DEPARTMENT OF HIGHWAYS ONTARIO			
BRIDGE DIVISION			
COUNTY RD. #10 UNDERPASS			
5 MI. WEST OF JCT. HWY. 404			
KING'S HIGHWAY No. 401		DIST. No. 8	
CO. LEJUNO & ADDINGTON			
TWP. RICHMOND & TRENDING		CON. 3 & 11	
PRELIMINARY			
APPROVED		SITE No. 10-31	
BRIDGE ENGINEER		W.F. No. 73-59	
DESIGN	K.G.B.	CHECK	
DRAWING	E.A.	CHECK	
		AS SHOWN	
DATE	MAY 1962	LOADING	
		12.5	
		516	
		DRAWING No.	D-5267-P1

W.P. 73-59 : County Rd. No. 10 Underpass
W.P. 74-59 : County Rd. Underpass
W.P. 177-61 : Mallorytown Rd. Interchange Underpass
District No. 8

Re: W.P. 73-59 & W.P. 74-59
Foundation Depth - Review

October 21, 1959.
FOUNDATION REPORT - D.H.O.
W.J. F 59-36 -- W.P. 73-59.

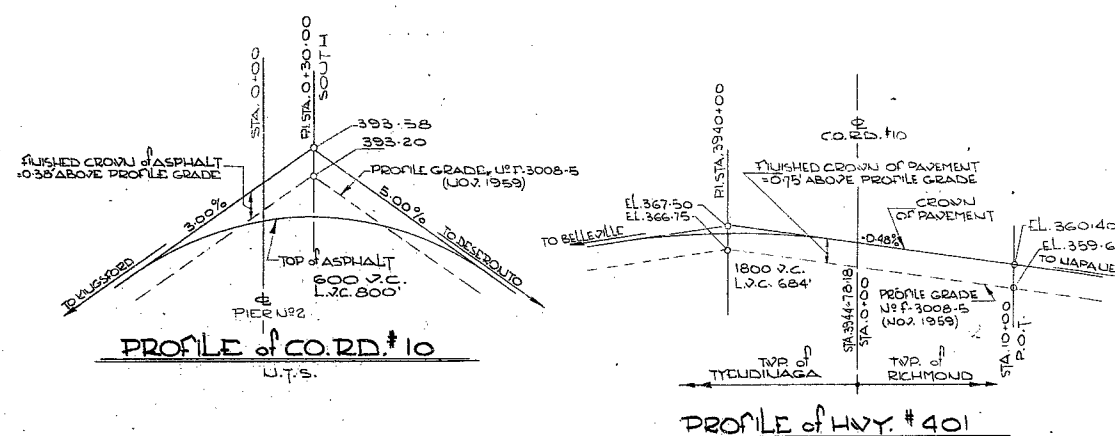
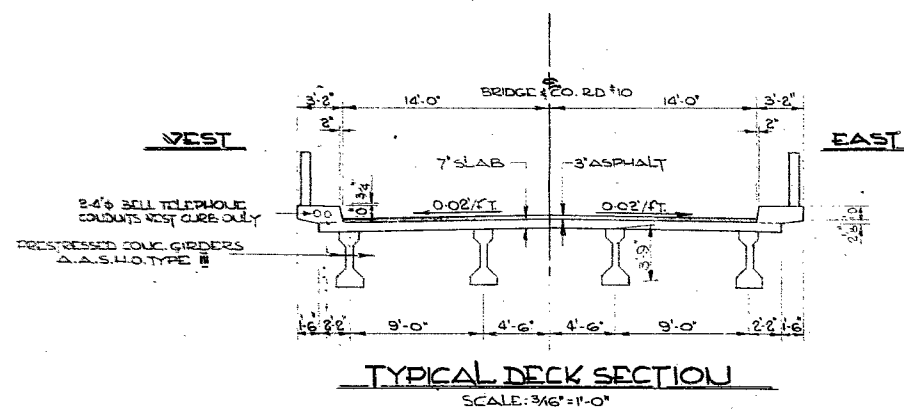
DIER NO 1 SHOULD BE PLACED AT ELEV. 357.00
OTHERWISE GOOD.
H.W. Allen, June/63.

For the other two structures (W.P. 73-59 and W.P. 74-59), the piers are founded on spread footings resting above bedrock within the overburden, while the abutments are founded on piles driven to bedrock. From the above, it is evident that conditions for the different supports are not identical. In view of the very dense state of packing of the overburden and its relatively small thickness, the difference in support has no significance.

For the structure W.P. 73-59, the north abutment footing is only about 3 feet above natural ground. It appears to us that instead of using piles here, a more economical way would be to place this footing on well compacted fill. On the south side, the abutment is about 10 - 11 feet above natural ground and maybe, even here, it would be more economical to put the abutment footing on well compacted fill.
